Product Equality Declaration

The differences between AP and previous as below:

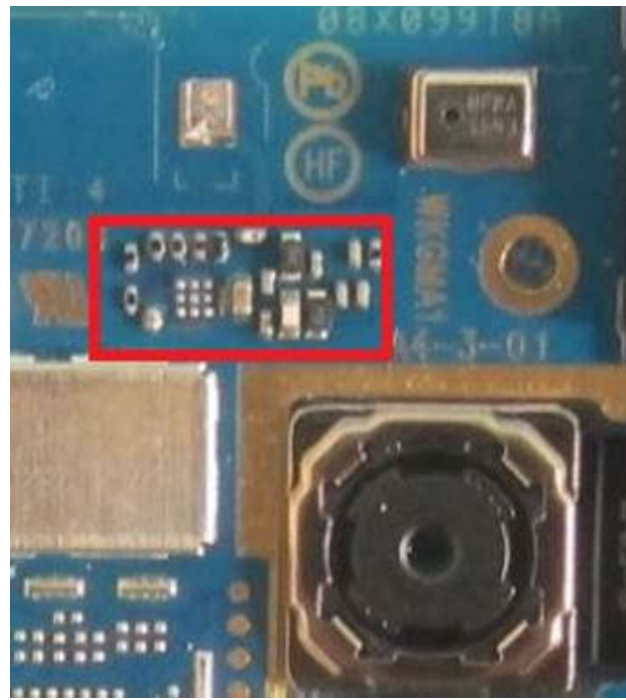
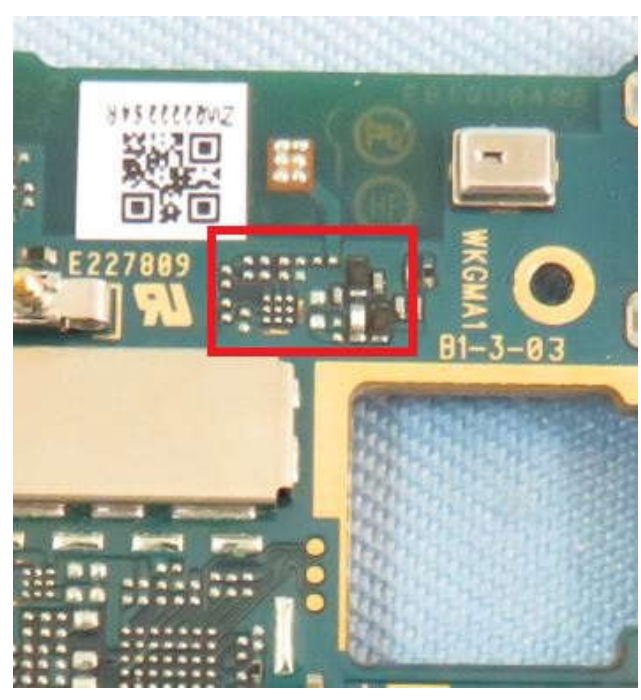
Previous 711913-02

Current 742708-02

Previous: Manual to remove SAR Sensor Chip and SAR Sensor shrapnel;

Current: Optimizing the BOM patch and removing the Sar sensor and its matching circuits.
